Subject: ICC-ES AC391 Acceptance Criteria for Continuous Rod Tie-down Assemblies

SUBJECT: AC391 Comments to version AC391-0609-R3

Subject: ICC-ES AC391 Acceptance Criteria for Continuous Rod Tie-down Assemblies

ICC-ES AC391 Rationale for Requested Revisions

Figure 1

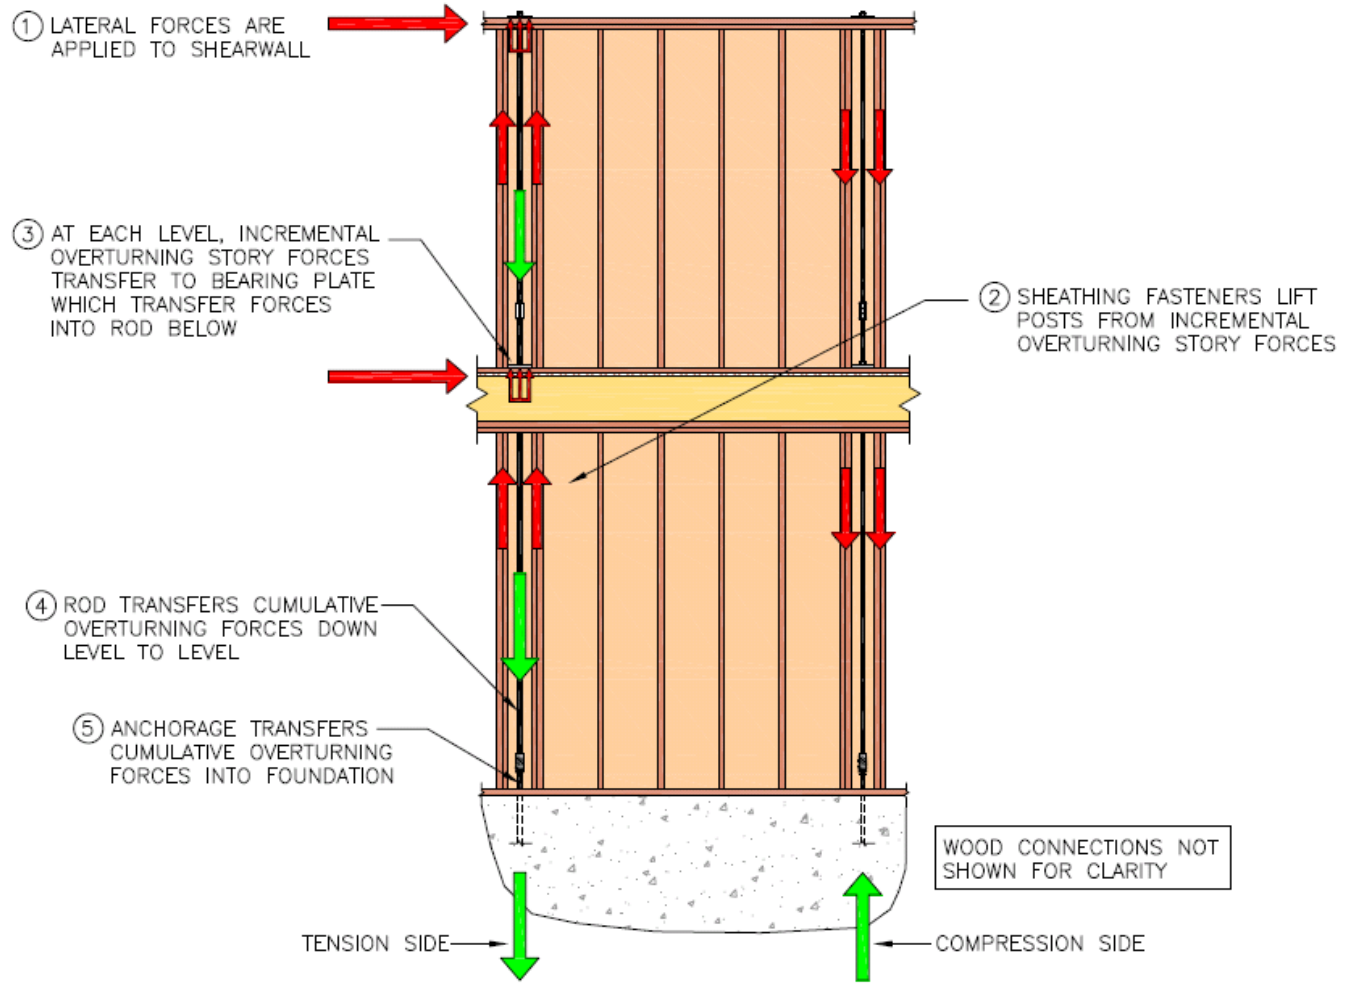
ICC-ES AC391 Section 3.4.4 entitled “ASD Allowable Load and Deflection” states that the allowable loads for the assemblies are based on the lowest determined allowable load of any component or connection of components comprising the intended assembly. This cannot possibly apply to overturning restraints in shear walls because the forces are added at each floor at the bearing plate and nut, as explained above. Therefore, the component with the lowest value for that level (most likely the bearing plate) cannot limit the rod capacities, as each component has to be looked at individually. See Figures 1 and 2 for an illustration of the differences in load paths and demand loads.

Figure 4

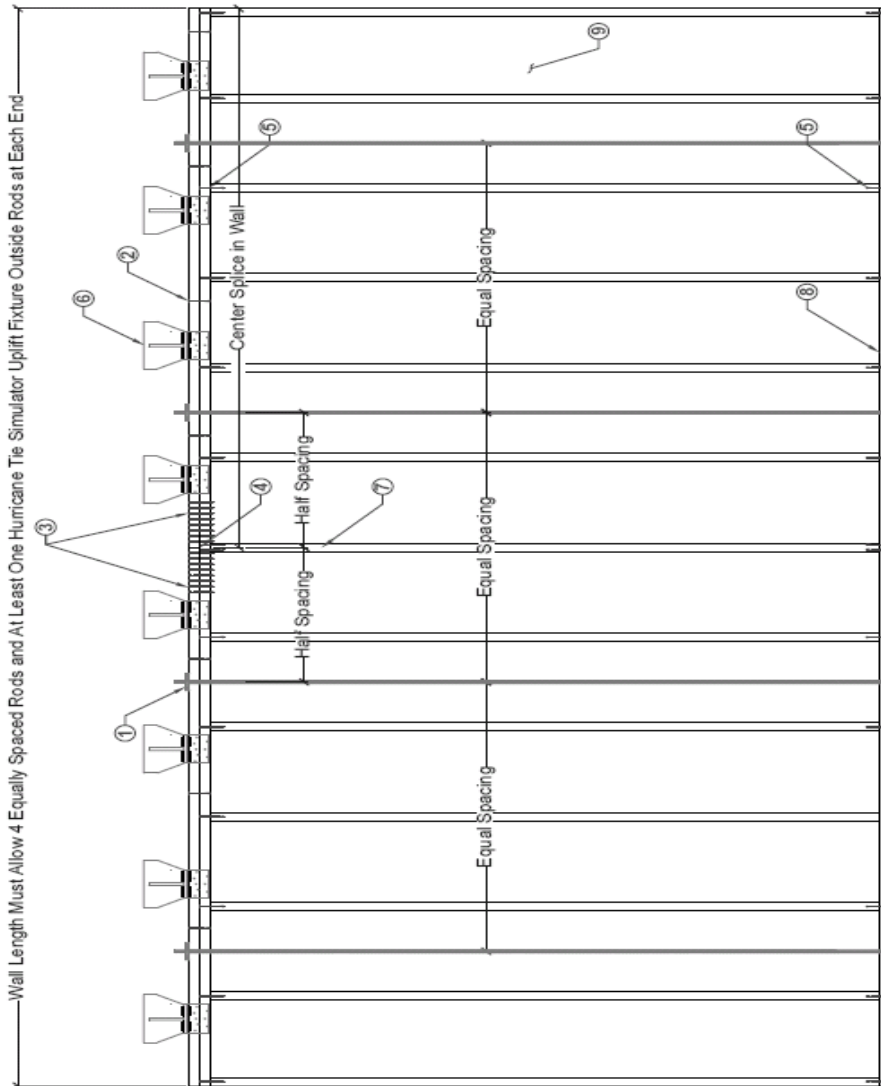
Comment #9 Section 3.4.6: We agree that the top plate splices could be connected together to transfer load. Obviously, different top plate splice connection details would yield different load

resistances. However, without testing of the entire assembly, calculations could only support a single wood top plate being relied on in bending to transfer loads to the tension rods. Testing of top plate splice connections could allow the use of two top plates in bending – increasing capacity, but ultimately limited by the calculated capacity of a wood double top plate. The additional requirement in Section 3.4.6 ensures that this is done properly. Additionally, testing has shown that the double top plate splice is critical. Please see figure 4 below.

3.4.6 Top Plate Calculations: For wind uplift resistance, ASD load values based on the wood top plate resisting bending between the tension rods shall be determined in accordance with the AF&PA NDS considering only a single member of the wood top plate, unless it can be shown by testing that double top plates are sufficiently fastened together at wood plate splices to provide increased bending capacity. Top plate splice details shall be provided in the code report. The maximum calculated deflection of the single wood top plate shall be limited to $L/180$, where L = top plate span equal to the distance between rod restraints.
